## Riley-Purgatory-Bluff Creek Watershed District Permit Application Review

**Permit No:** 2022-037

**Project:** The applicant proposes to remove approximately 184 cubic yards of sediment from a stormwater pond to restore treatment capacity of the pond (which is not a public water). The city also plans to restore the outlet from the pond to the original as-built condition including the outfall into an on-site wetland to maintain stormwater drainage.

**Reviewer:** Scott Sobiech, PE Barr Engineering

**Wetland Buffer Map**  
 Lake Lucy Road Improvement Project  
 City of Chanhassen

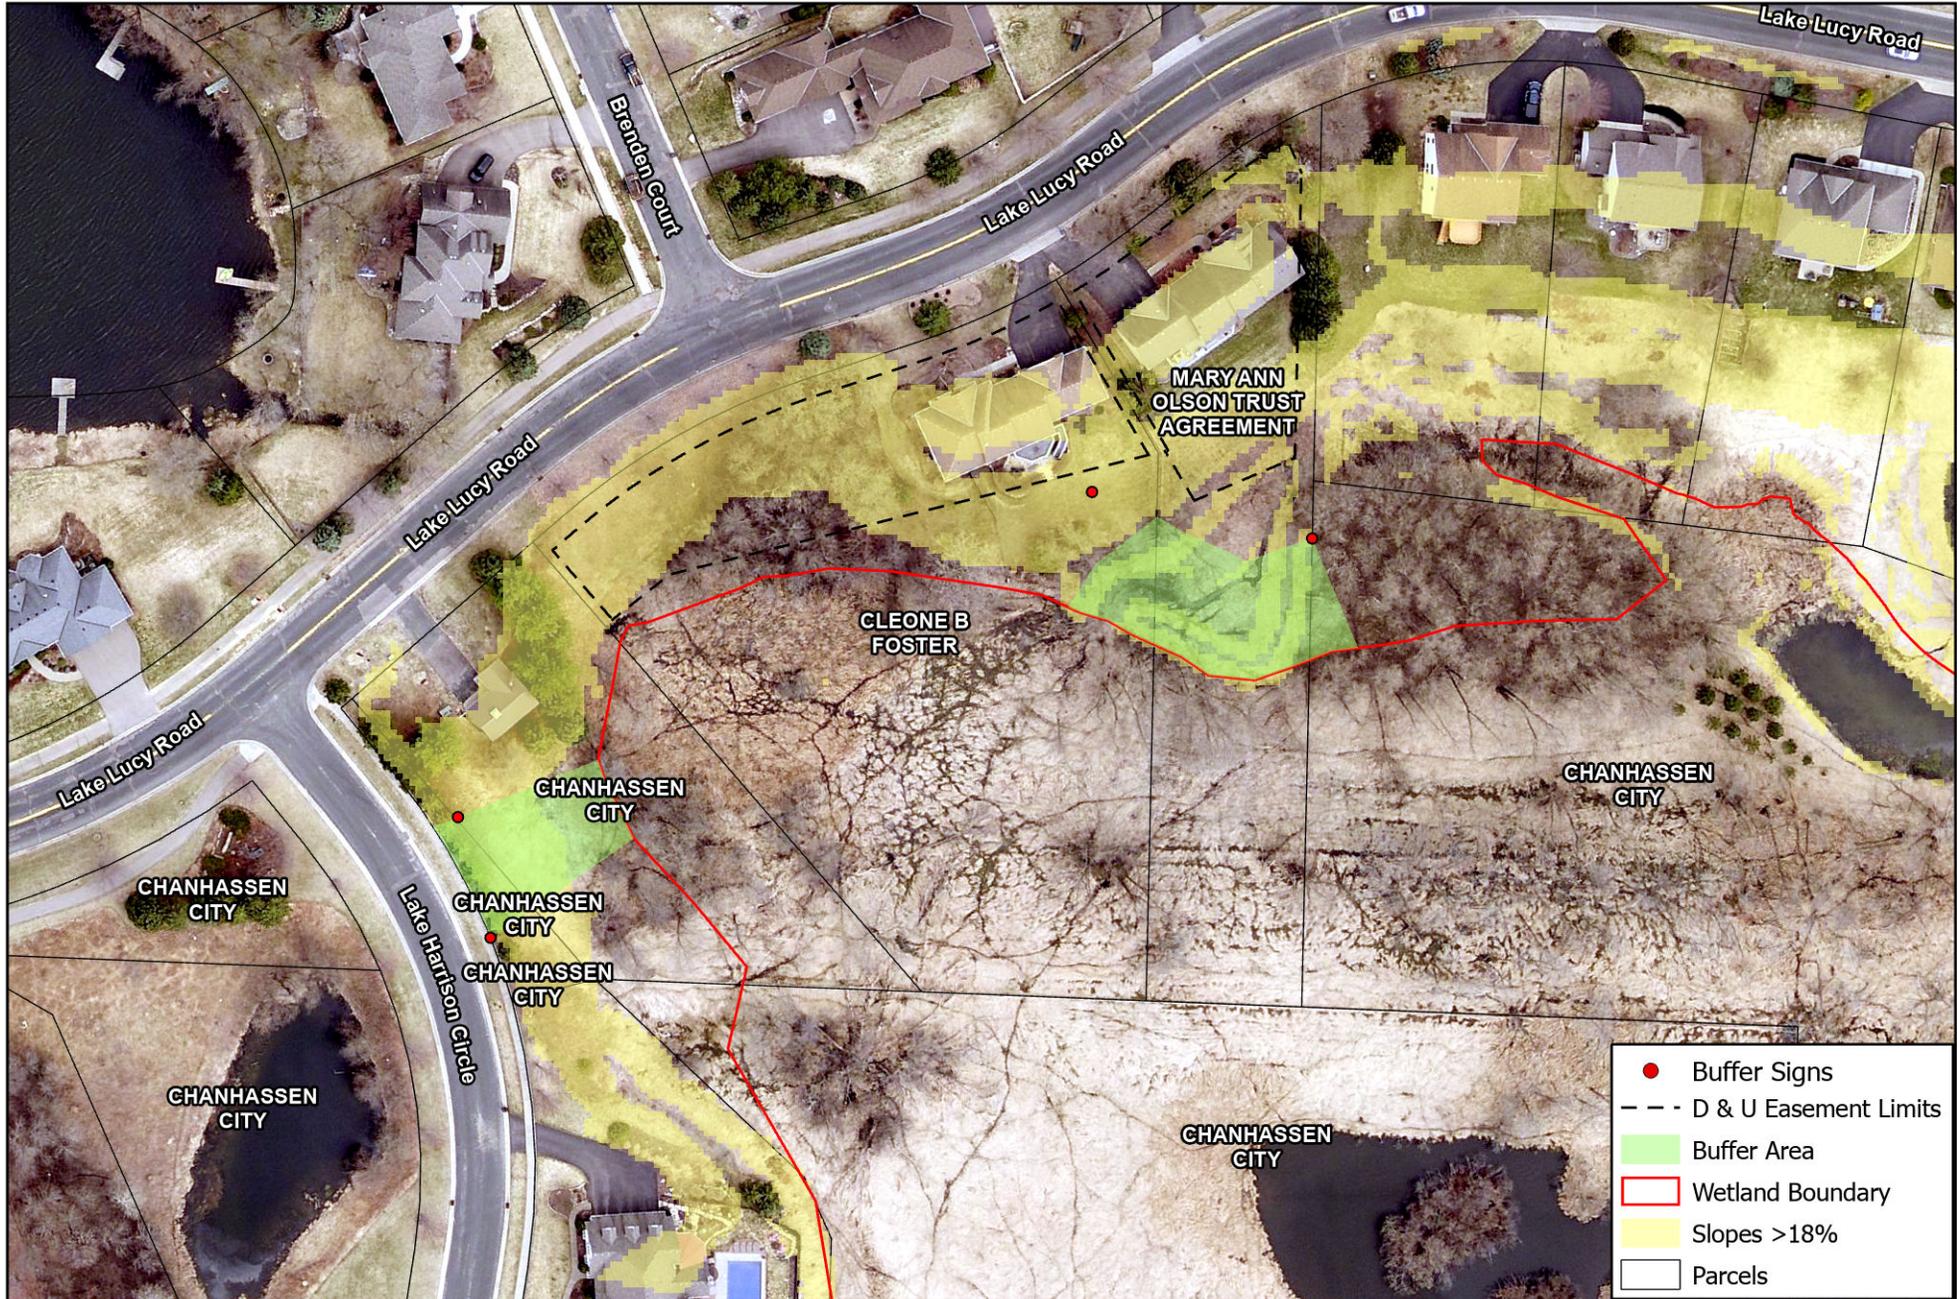
- D1. Buffer areas and maintenance requirements must be documented in an agreement submitted in draft for form approval by RPBCWD. The agreement must include an exhibit clearly showing the buffer area and monument locations.

2. Permit applicant must provide the name and contact information of the general contractor responsible for the site. RPBCWD must be notified if the responsible party changes during the permit term.
3. Buffer areas and maintenance requirements must be documented in an agreement submitted in draft form for review and approval by RPBCWD. The agreement must include an exhibit clearly showing the buffer area and monument locations.
